IREDELL COUNTY HEALTH DEPARTMENT

PERMIT # 215720

IMPROVEMENT PERMIT / AUTHORIZATION TO CONSTRUCT / OPERATION PERMIT / EXISTING SYSTEM

SITE ADDRESS: 396 PONDEROSA CIR. - Mooresville PHONE: 805-886-1402 ALT. PHONE:

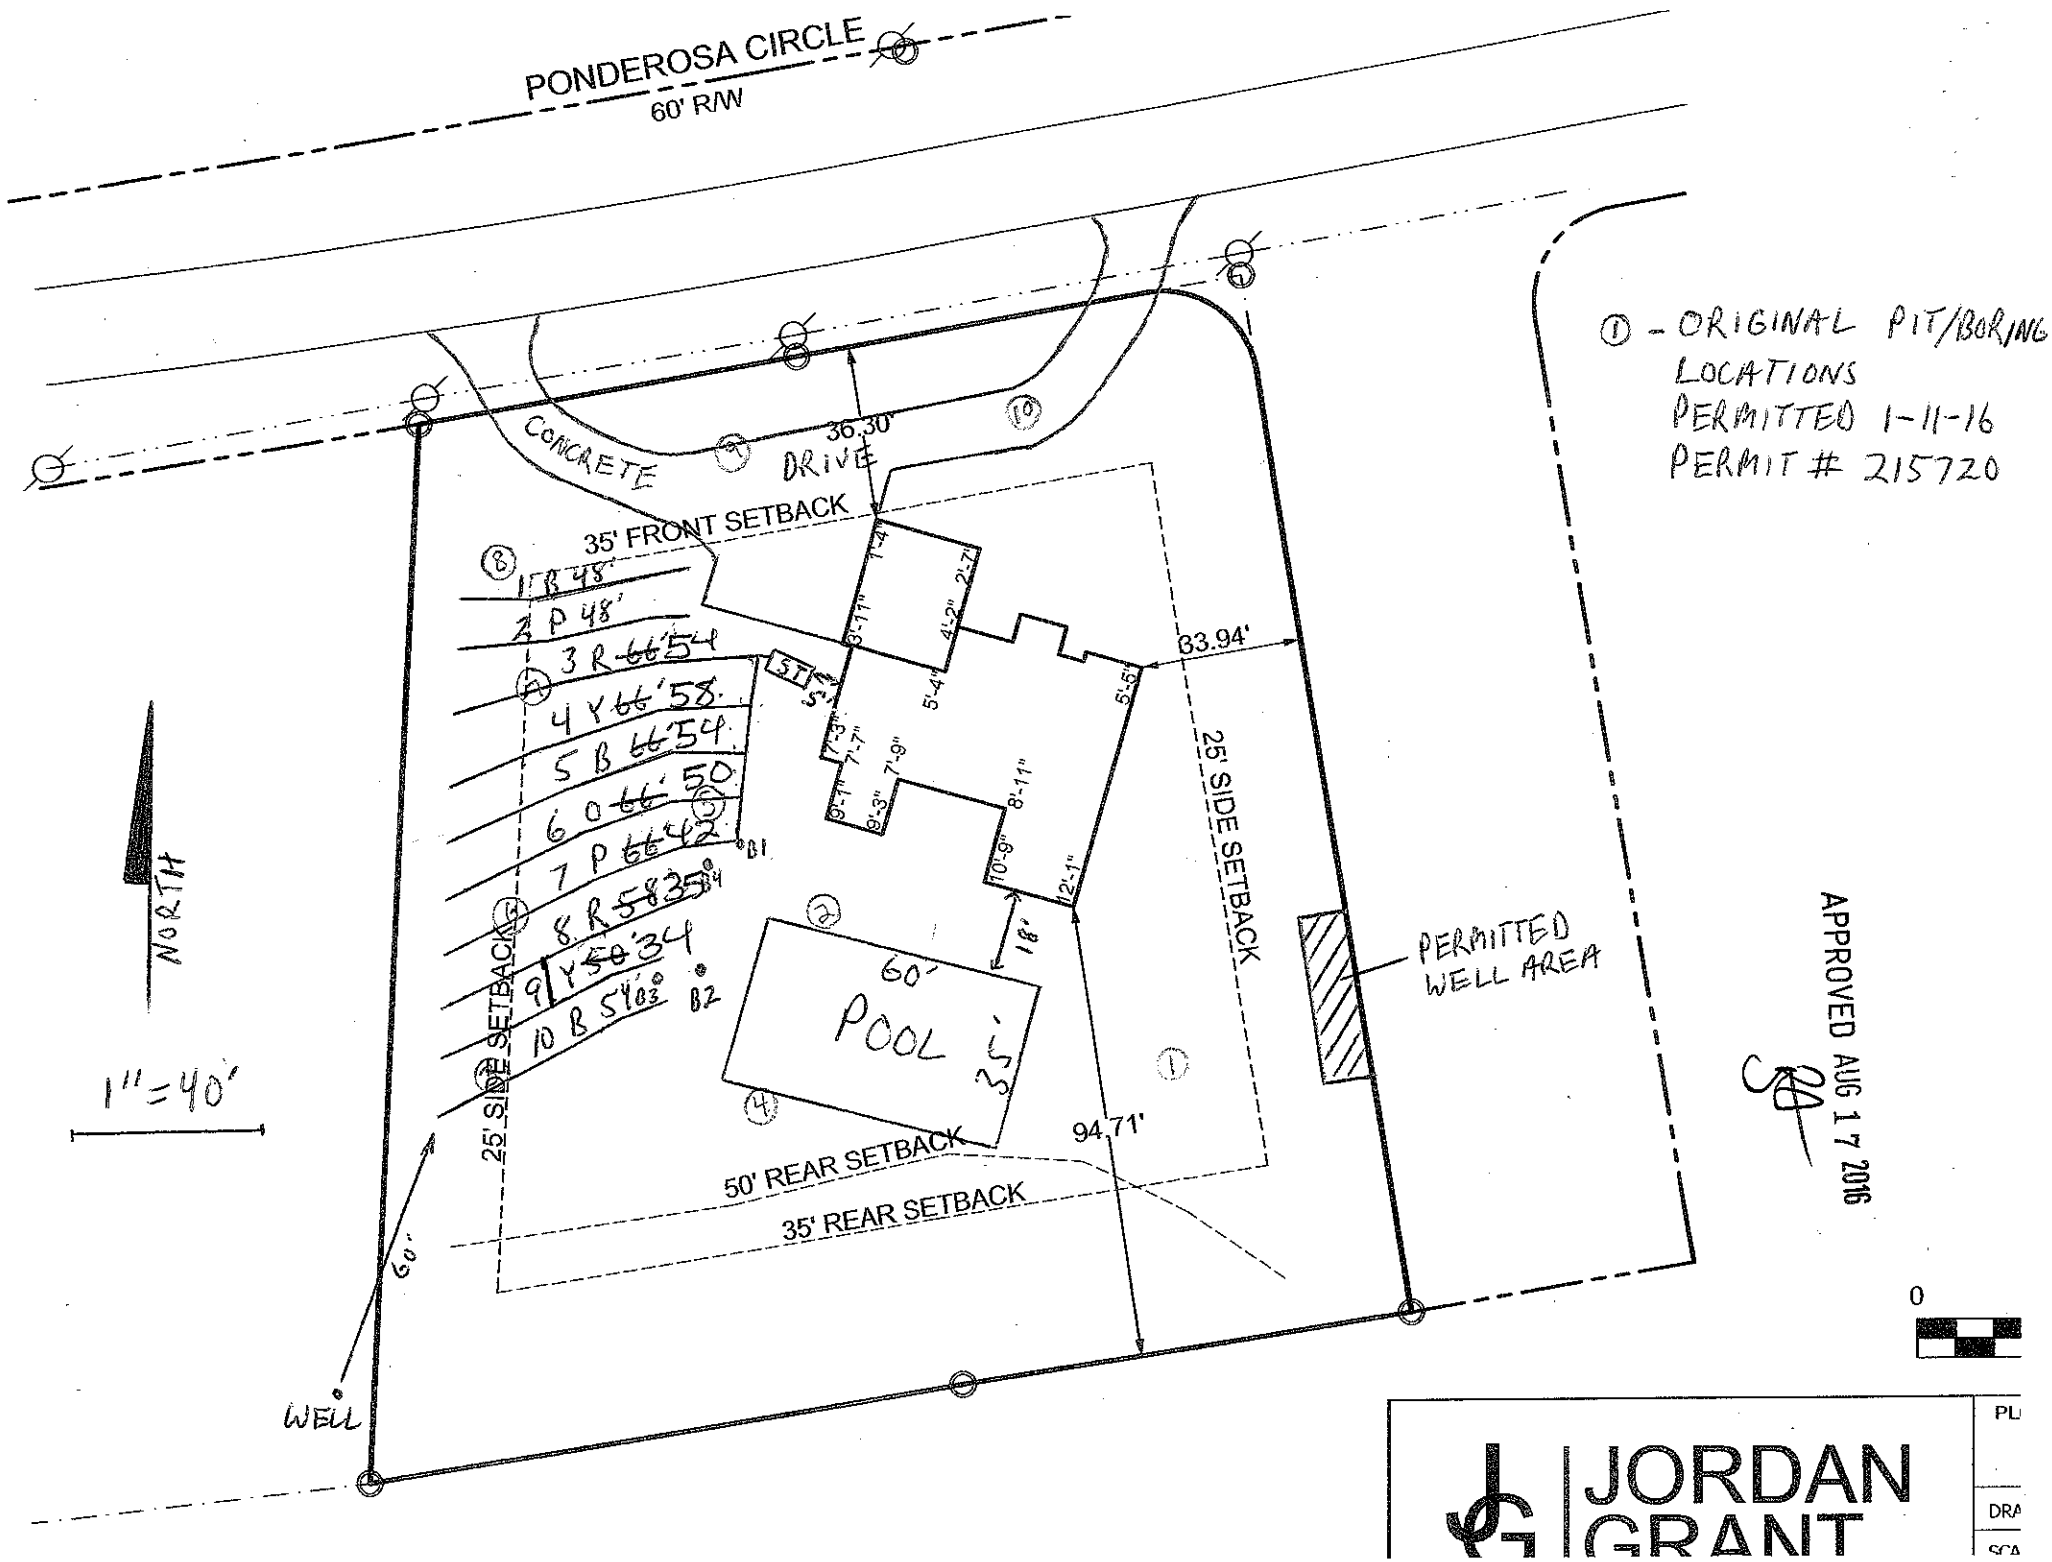
Comments / Conditions: Water/Gas line at end of proposed drainlines; had to go into repair area with initial system changed repair to PPBPS

Installed Quick 4 for Drainlines

2-24-2016: During a site visit on 2-22-2016, it was observed that the house box was not staked the required 25' from the side PL. Owner/Applicant STRONGLY ENCOURAGED to coordinate house box location w/ Surveyor prior to beginning construction. -SP
